ADDENDUM #1

11/17/2025

Etna High Point Park Site Improvements Project

PROJECT c24232

sheet name
ELECTRICAL DETAILS

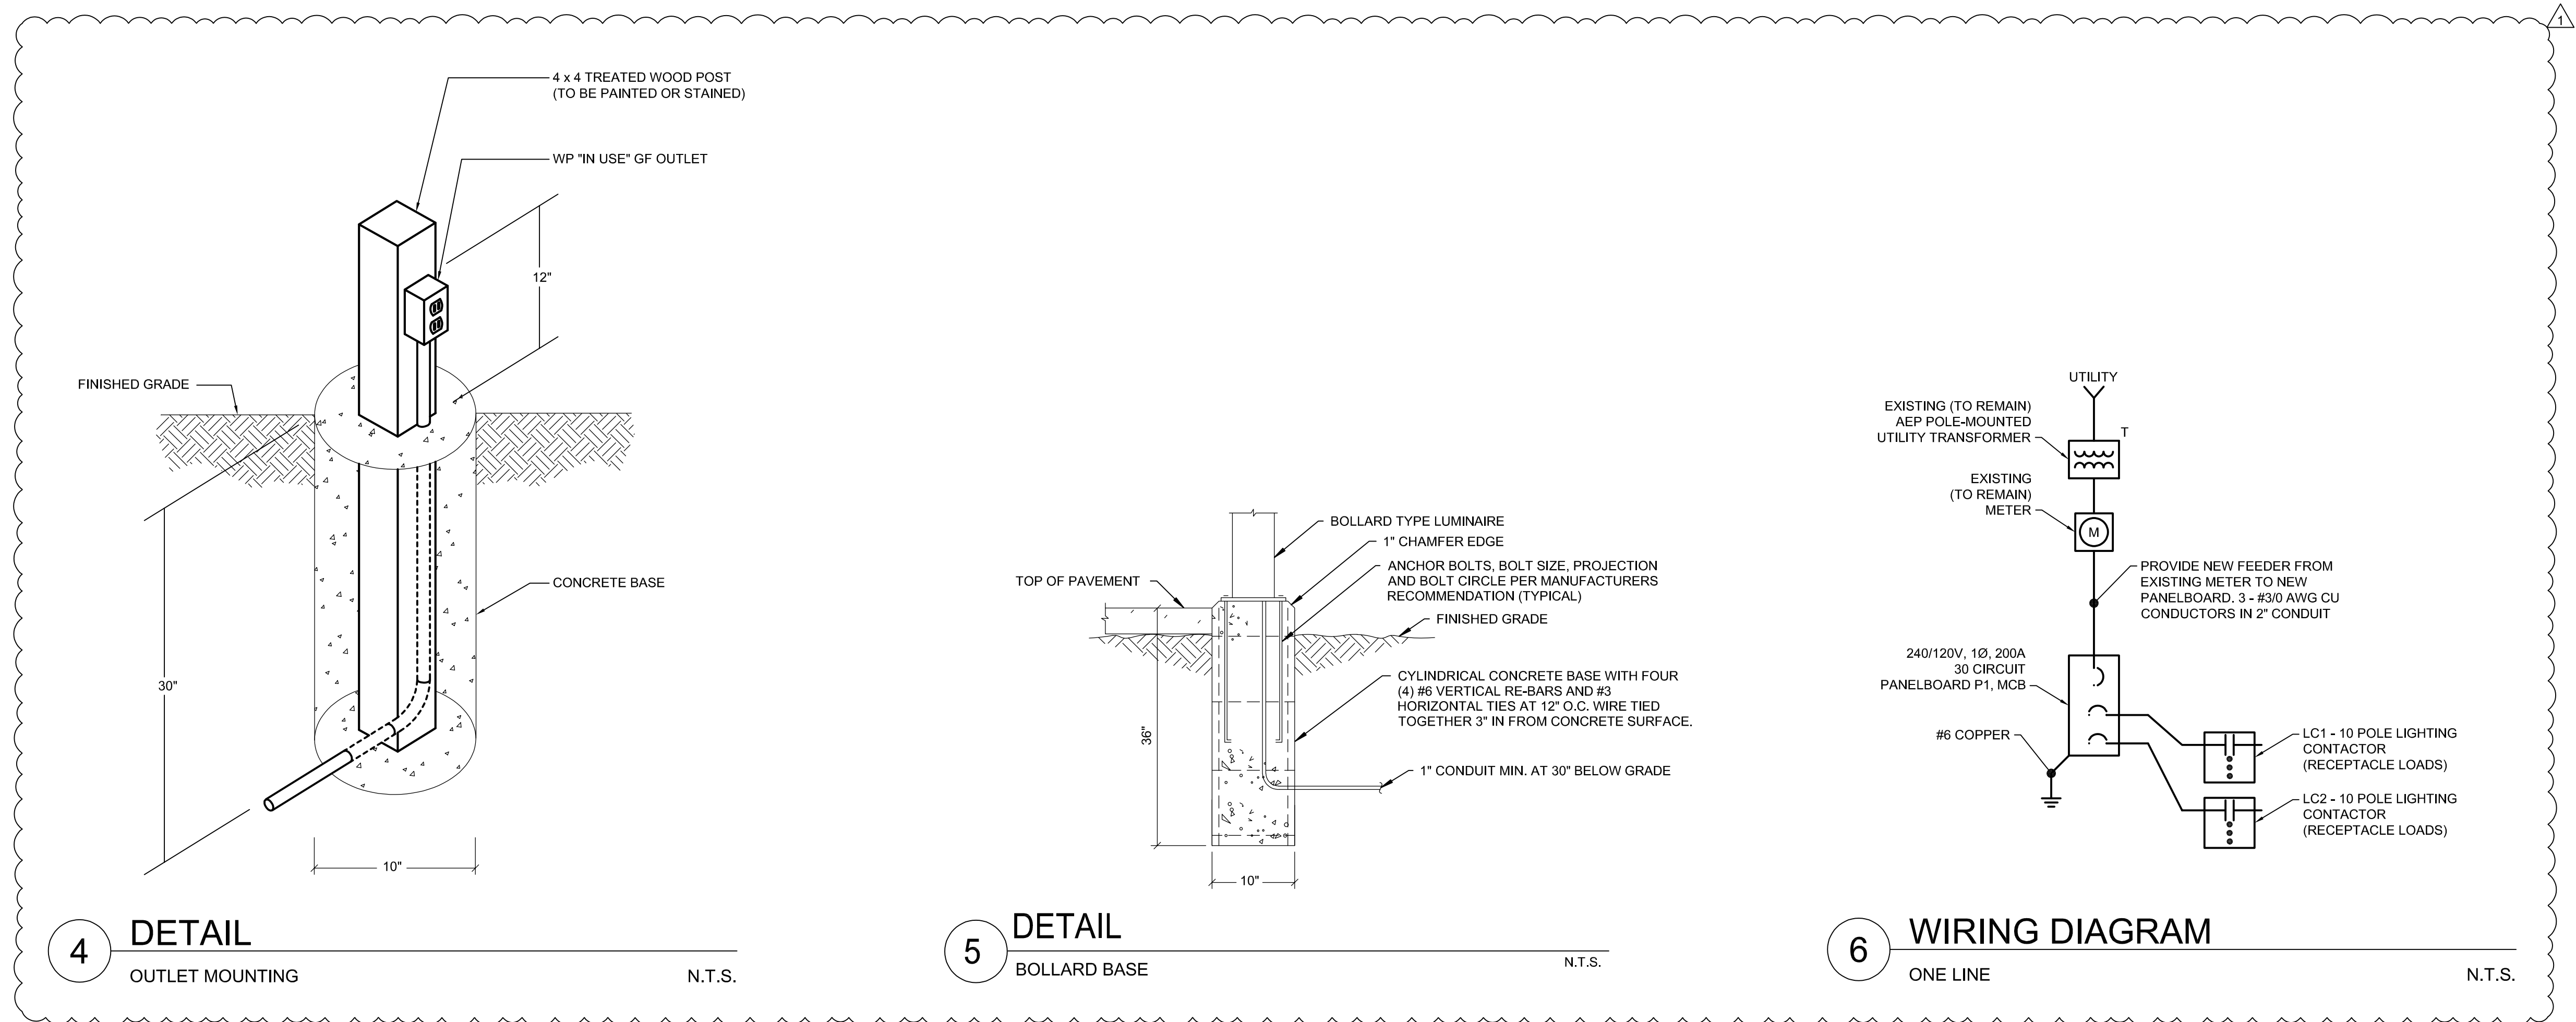
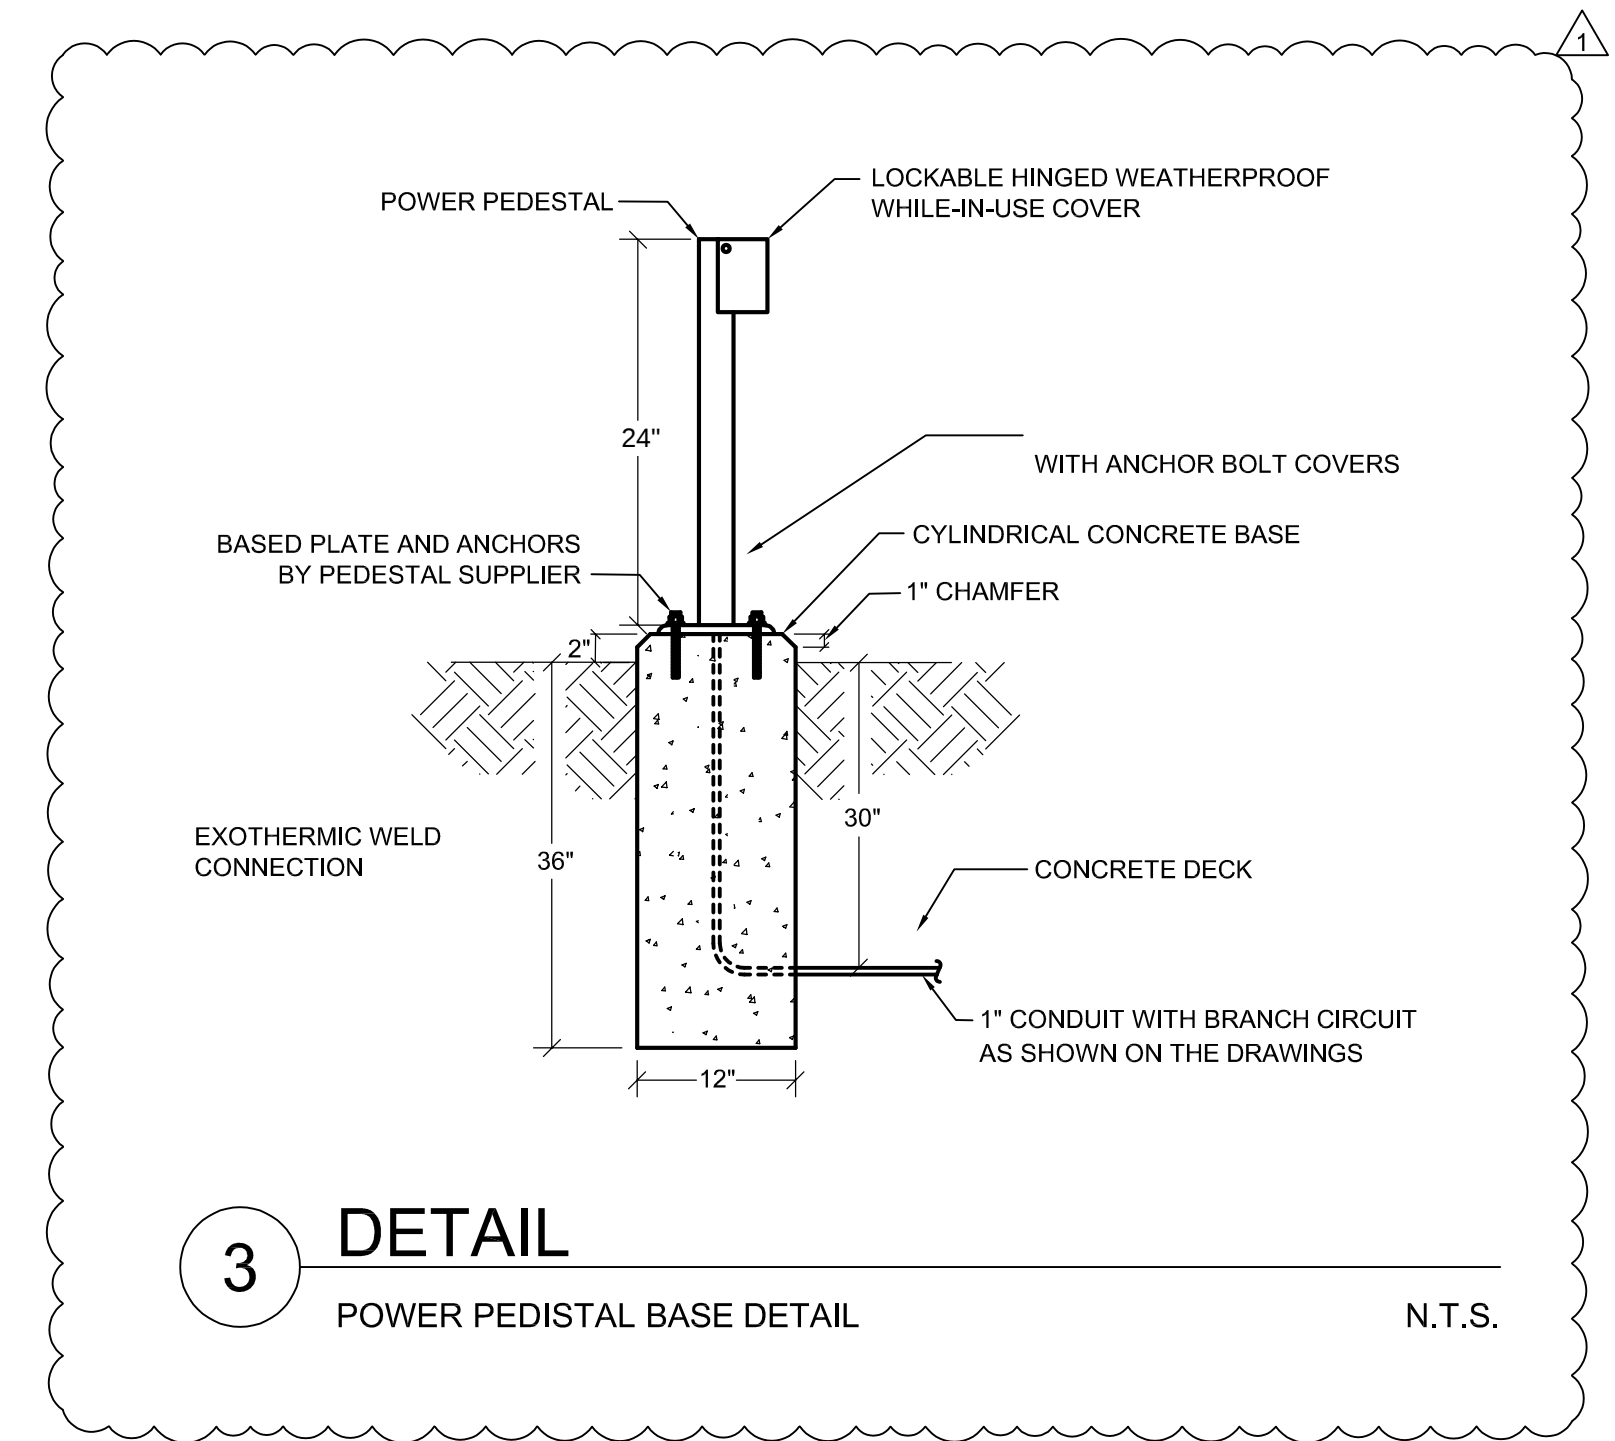
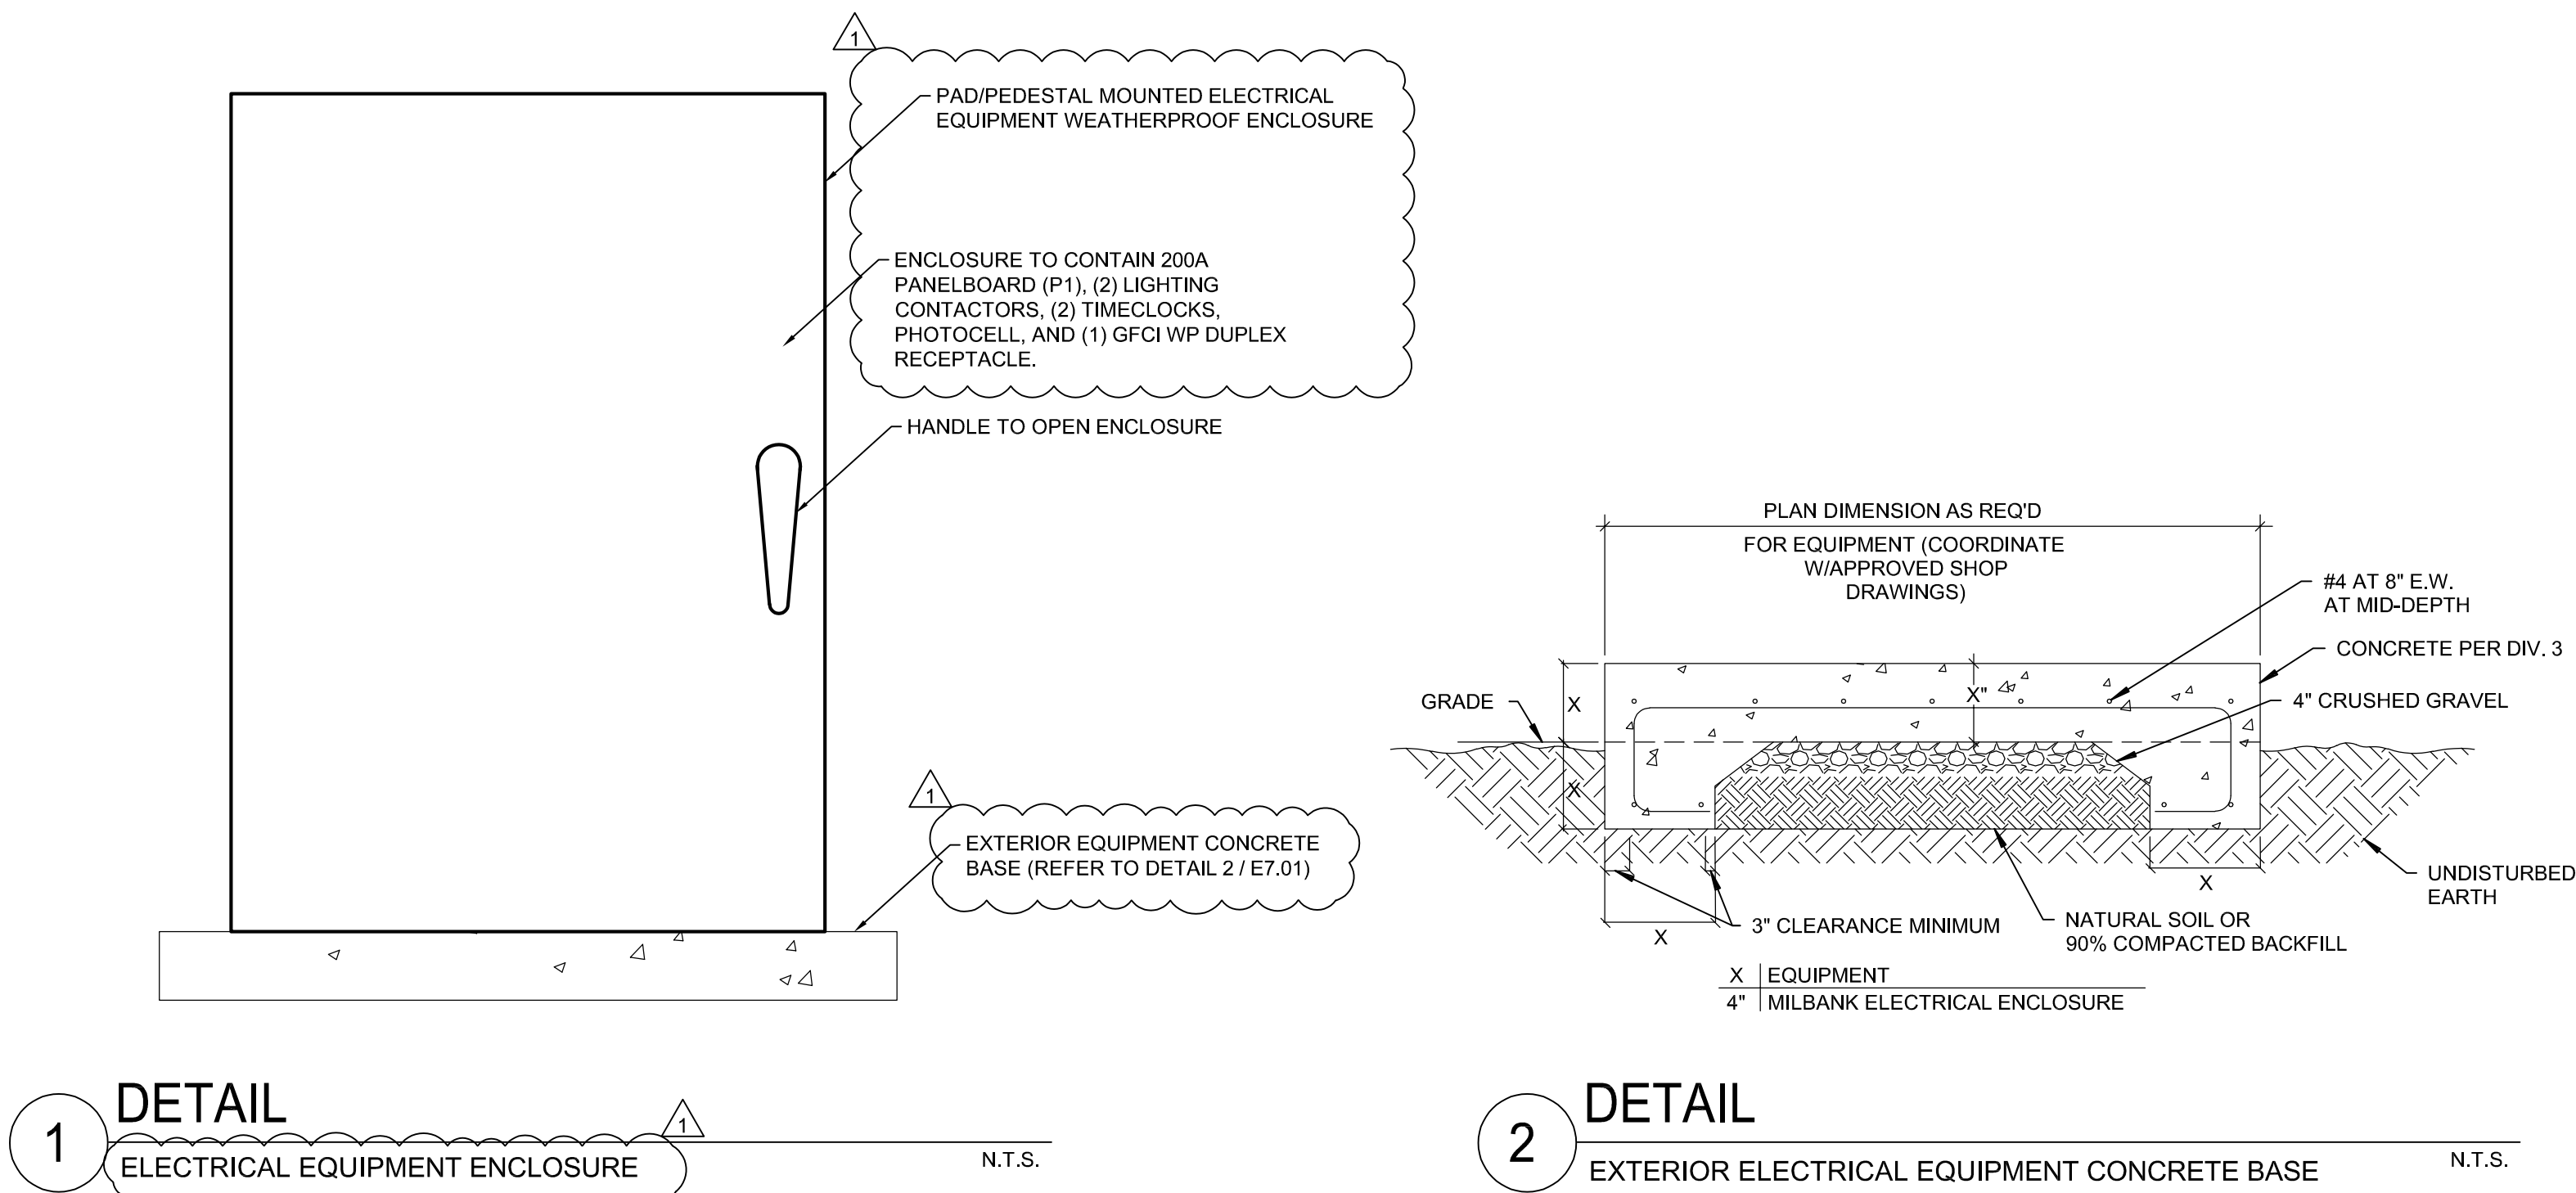
F. SHEET E7.01:

- a. Revised Detail 1 to change from Milbank enclosure/components to generic enclosure with clarification of equipment to be installed within.
- b. Revised detail 3 to move on page and to revise height to match E2.01.
- c. Revised details 4 & 5 to move on page and to define the diameter of the concrete bases.
- d. Added One Line diagram as shown for clarification.
